RE: Mountainside Church Addition Grading and Drainage Plan Engineer's Stamp Date: 01/30/18

Hydrology File: J22D068

Based upon the information provided in your resubmittal received 02/28/2018, the Grading and Drainage Plan is approved for Building Permit.

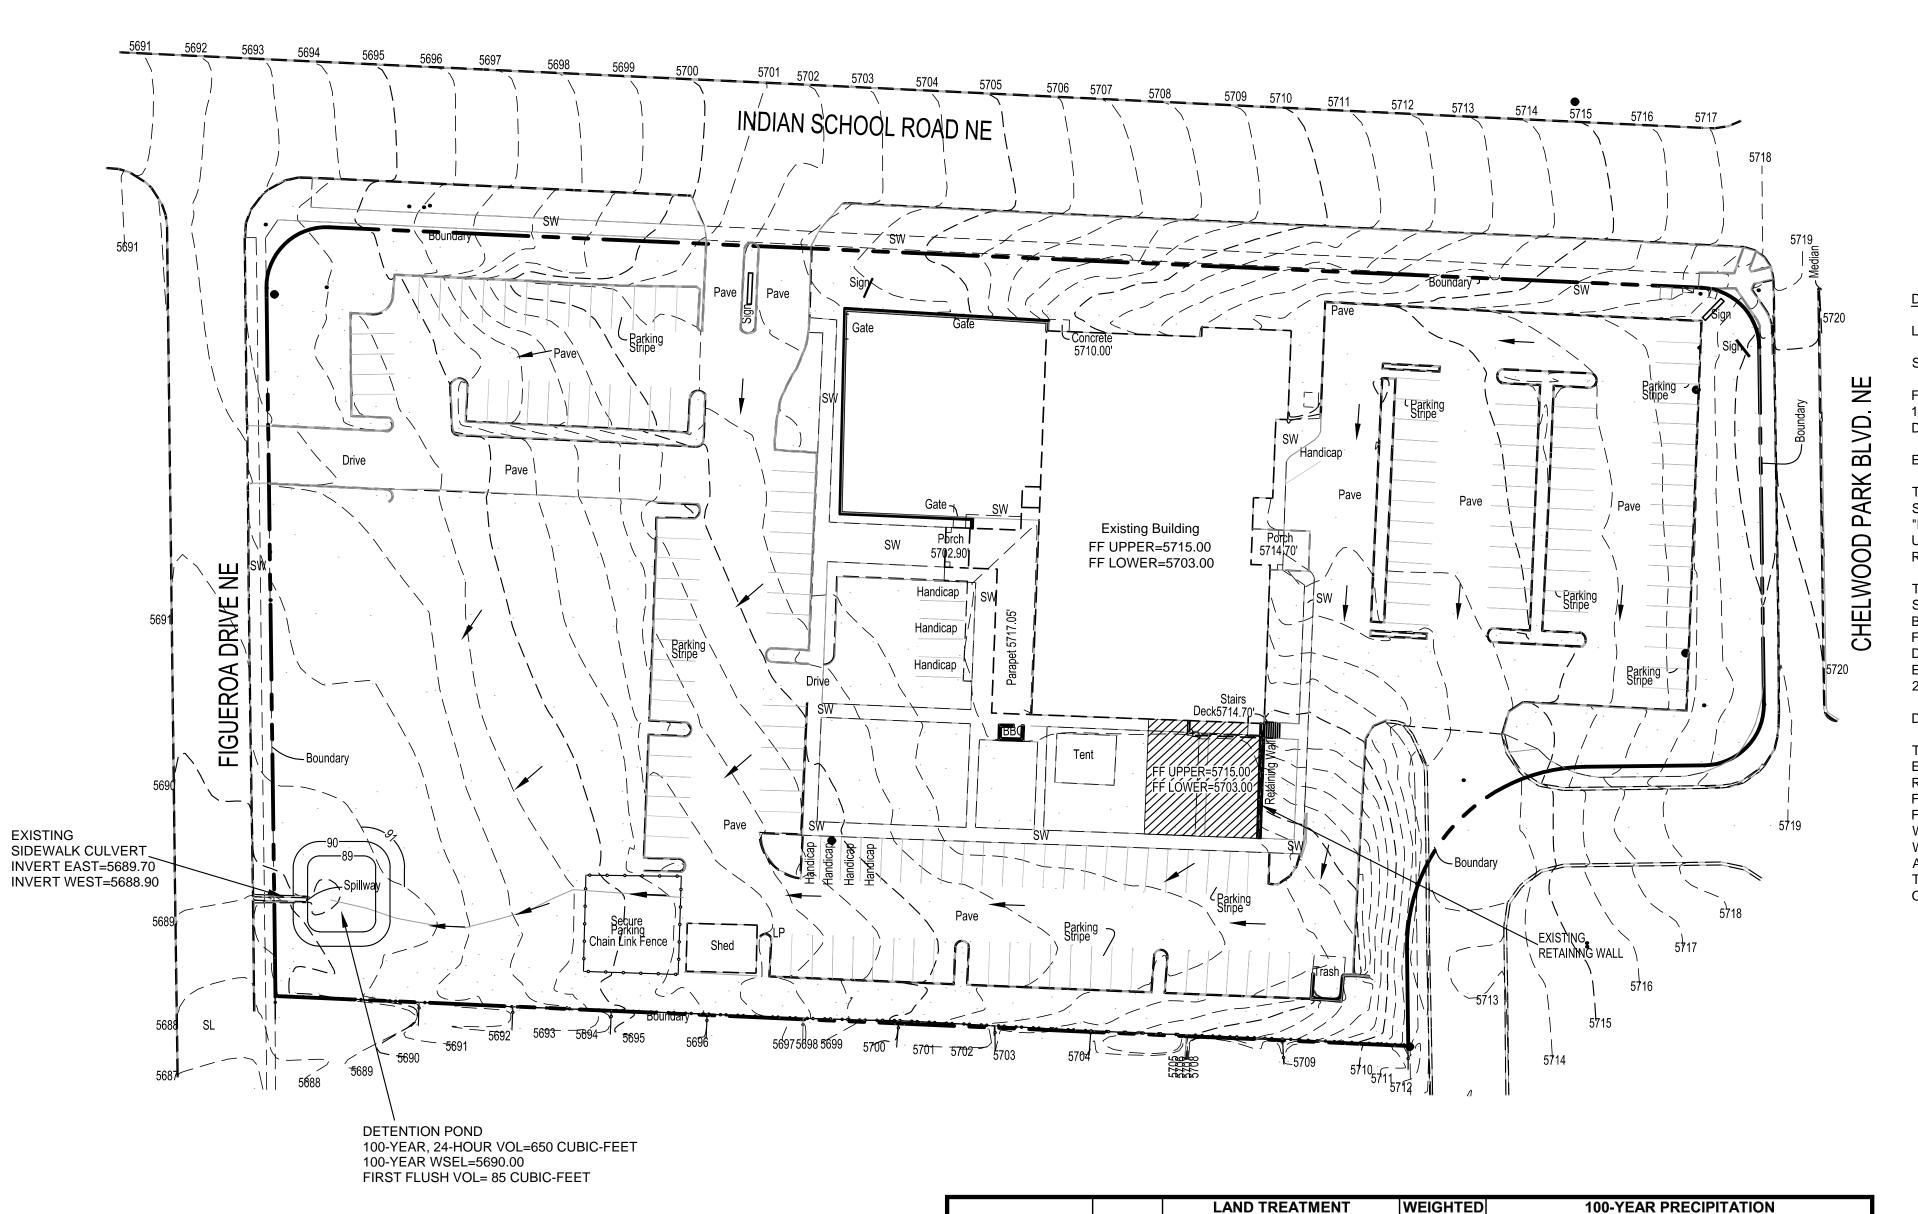
Please attach a copy of this approved plan in the construction sets for Building Permit processing. Prior to Certificate of Occupancy release, Engineer Certification per the DPM checklist will be required.

Please provide a Private Facility Drainage Covenant per Chapter 17 of the DPM for detention pond prior to Certificate of Occupancy. I have attached a word document of this for your use. Please submit this on the 4th floor where you drop off the DRC plans. A \$25 fee will be required.
